JEM AF1-MkII Fan Blade Changes

11-Feb-25

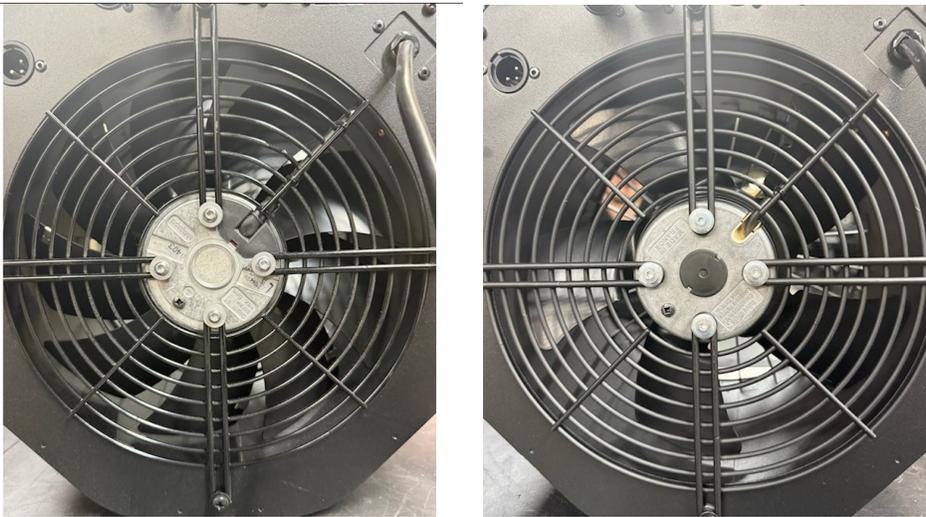
Why does my newer JEM AF-I MkII have a different fan blade count to my older units?

For over 20 years...The original AF1 and newer AF1-MkII fan units had a 9 blade fan installed.

This has now (after all this time) become obsolete from the supplier so a new comparable fan has been sourced.

The newer AF1-MkII fan units now have a 5 blade fan installed.

Any 230V unit after serial I4509793701 (production date 1st March 2023) or any 115V unit after serial I4509794101 (production date 3rd April 2023) will have the new 5 blade fan installed.

If an older '9 blade' fixture is received for fan unit repair it will have the new 5 blade fan unit installed.

This new 5 blade fan will move more air and will possibly be slightly louder in operation compared to the older 9 blade unit.
